Access Assessment Report

101-105 Old Pittwater Road, Brookvale

Reference No: 115586-Access-r02.1

Date: 22 April 2022

Figure: Minimum lift floor sizes.

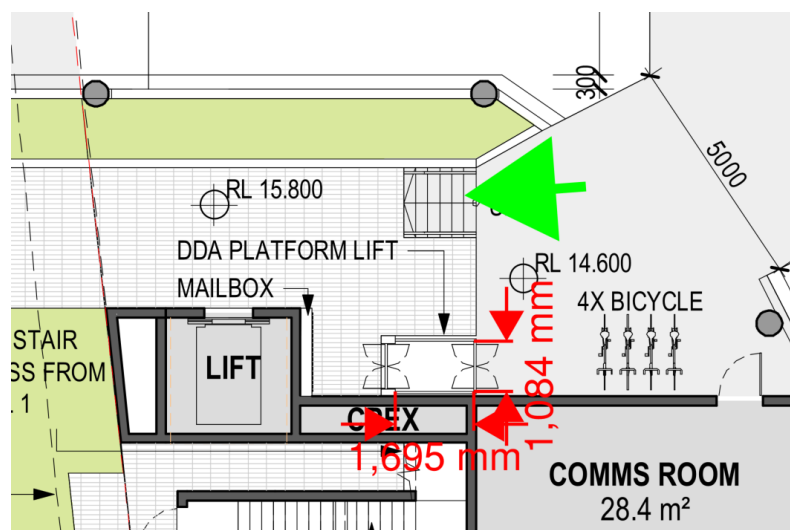
- (a) The low rise platform lift stairways serving as the only means of access from the ground floor lift landing to the warehouse SOU's is to demonstrate a minimum lift landing of 1100mm wide by 1400mm deep is achievable as prescribed by Clause E3.6 of the BCA.

FIGURE 28 (in part) HANDRAILS TO STAIRS WITH INTERMEDIATE LANDINGS

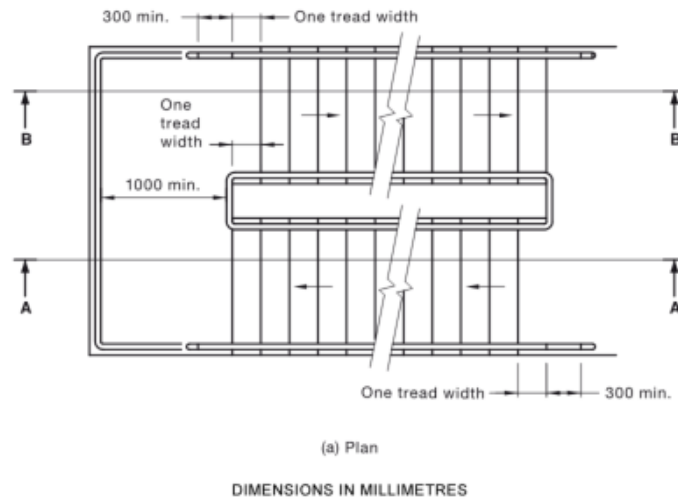
- (b) All fire isolated stairways are to incorporate a one tread off-set to ensure inner handrail complies with Clause D2.17 and Clause 11 (f) & (g) of AS1428.1-2009. (Refer to BCA Report for commentary on 'Open Stair' serving Level 1 of the building)

Figure: fire isolated stairways to incorporate one tread off-set to achieve level handrail at landing.

Figure: Door widths to achieve minimum 850mm clearance.

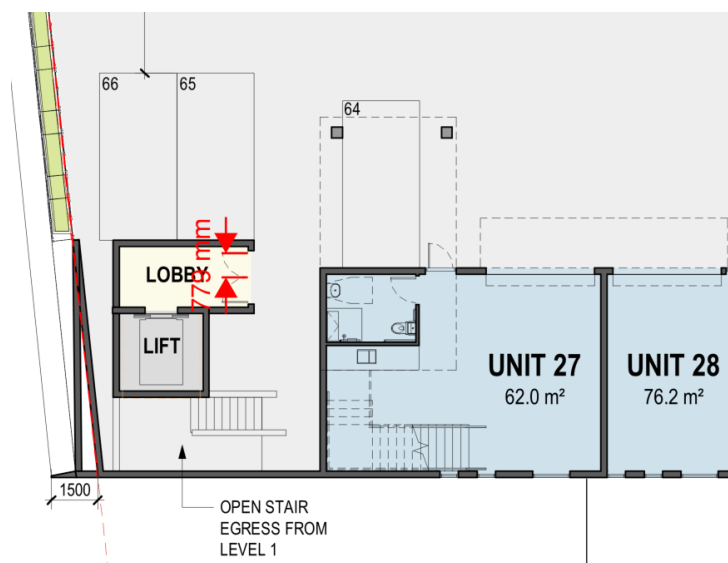
- (c) Each required exit stairway serving the enclosed office mezzanines, and any other non-fire isolated stairway within the common areas of the building, is to incorporate accessible features of Clause 11 & 12 of AS1428.1-2009 including, but not limited to, TGSIs, luminance contrasting nosing strips, double handrails incorporating extensions and turn downs.
- (d) Where the total combined floor area of the office mezzanines storeys contained within the building exceed 200m² and the total RIS for the building exceeds 3, a non-fire Performance Solution may address the departure from Clause D3.3 (f) to rationalise lift or ramp access being omitted from the design of each mezzanine.
- (e) At least a single door leaf providing access to the lift lobby on the second floor of the building is to maintain a clear width of 850mm.
